PRODUCT CHANGE NOTIFICATION (PCN)

AMJE0909-0150-GNB-24
MODULAR CABLE

CHANGE NOTIFICATION: PCN 20220509_AMJE0909-0150-GNB-24

DESCRIPTION OF CHANGES:
CHANGE OF DATA SHEET
CHANGE OF DATA SHEET
New Draw.-No. ASS_7945_CArev02

AMJE0909-0150-GNB-24 OLD VERSION

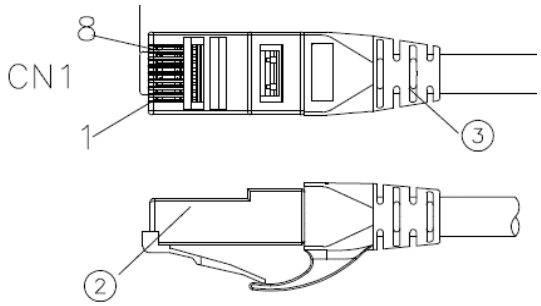
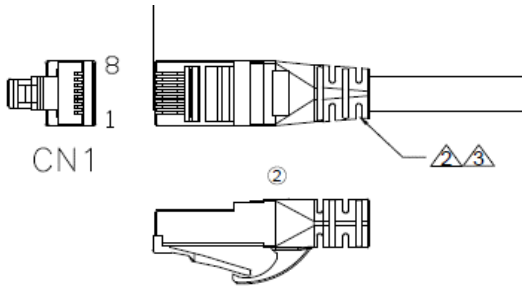
③	Molding	PVC 45P Color: see order code	NA	KG
②	CONNECTOR	RJ45 8P8C two fork Short type 3u" gold plated	2	PCS
①	CABLE	CAT6 UTP (24AWG*1PR)*4+PVC OD=5.8±0.3MM Color: see order code	NA	MM
NO:	NAME	DESCRIPTION	Q'TY	UNIT

3	Molding	PVC 65P Color: see order code ②	NA	KG
2	CONNECTOR	RJ45 8P8C PLUG 3u" gold plated ②	2	PCS
1	CABLE	CAT6 U/UTP (24AWG*1PR)*4+Cross+PVC Jacket OD=5.8± 0.3MM Color: see order code ②	NA	MM
NO:	NAME	DESCRIPTION	Q'TY	UNIT

Drawing-No.
ASS 7945 CA

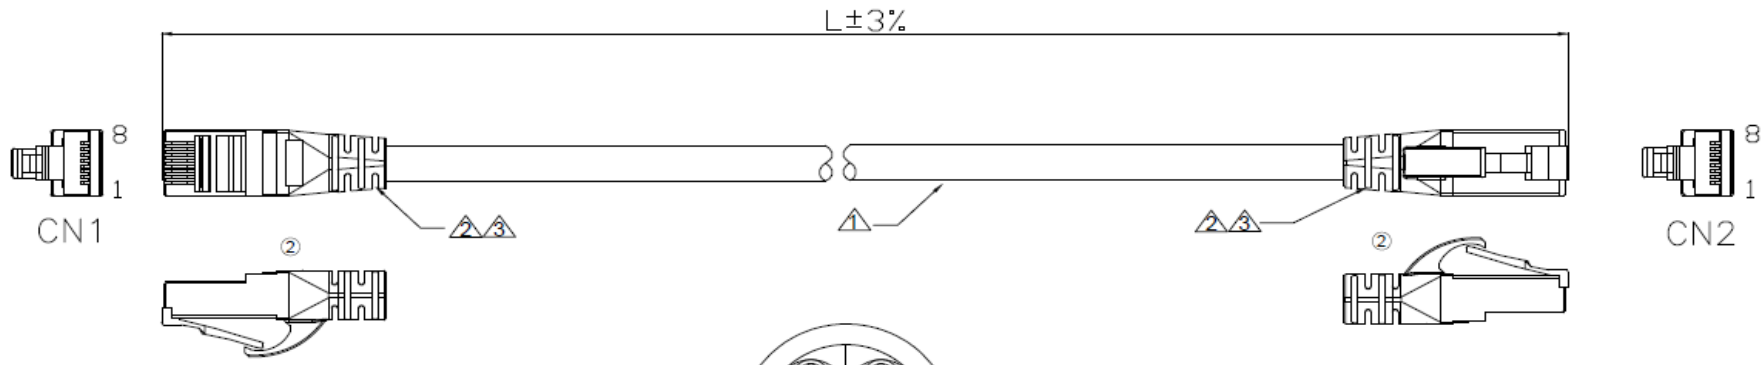
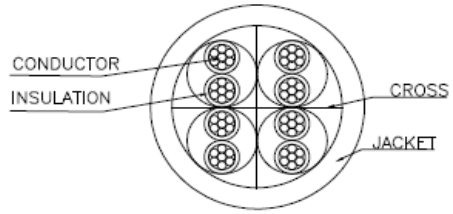
Id.	Modification	Date	Name
②	Change the plant	09.05.2022	Luca
①	Update the WSW order code	02.06.2017	Amy
⓪	Drawn	30.03.2017	Amy

NO:	NAME	DESCRIPTION	Q'TY	UNIT
3	Molding	PVC 65P Color: see order code ②	NA	KG
2	CONNECTOR	RJ45 8P8C PLUG 3u" gold plated ②	2	PCS
1	CABLE	CAT6 U/UTP (24AWG*1PR)*4+Cross+PVC Jacket OD=5.8± 0.3MM Color: see order code ②	NA	MM
